**2.1.8 AMENDMENT 8: CPW**

**Extended plinth and metal PPC lining to UKPN substation in lieu of louvre overcladding**

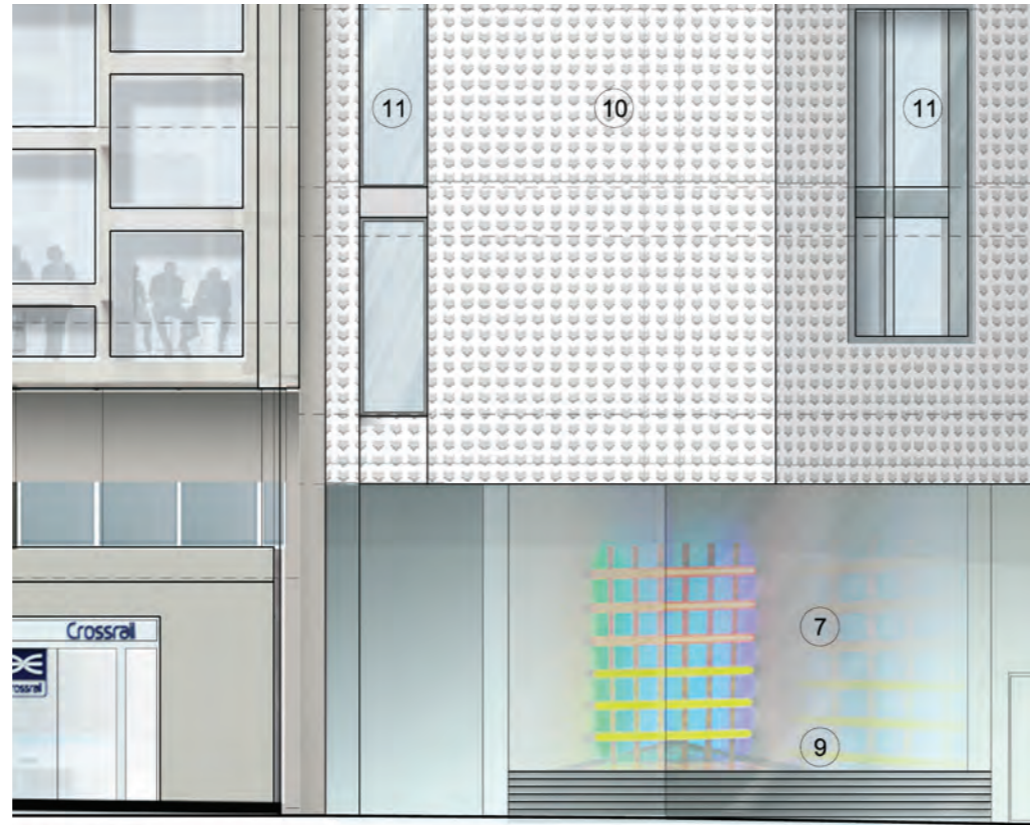
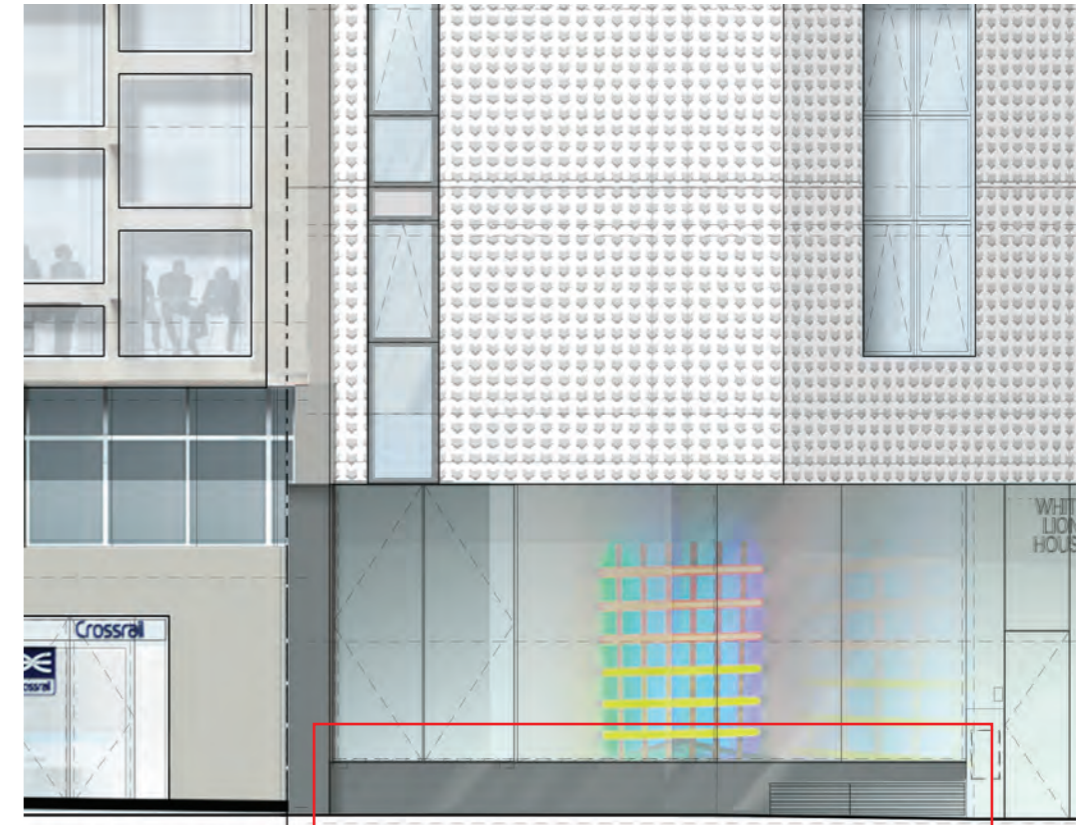
The area in question relates to the existing UKPN substation below CPW affordable housing. At the request of UKPN, it has been necessary to increase the existing plinth towards the North to provide a wider landing transfer space. This allows suitable access for the maintenance & replacement of their transformers.

Additionally, due to strict UKPN specification requirements it has not been possible to overclad the plinth face with new architectural louvres as previously intended as this would have a detrimental effect on the ventilation free area. It is therefore proposed to replace this with a new PPC metal cladding in lieu of the louvres and retain the existing louvre opening within. The metal lining will remain flush with the glazed facade above.
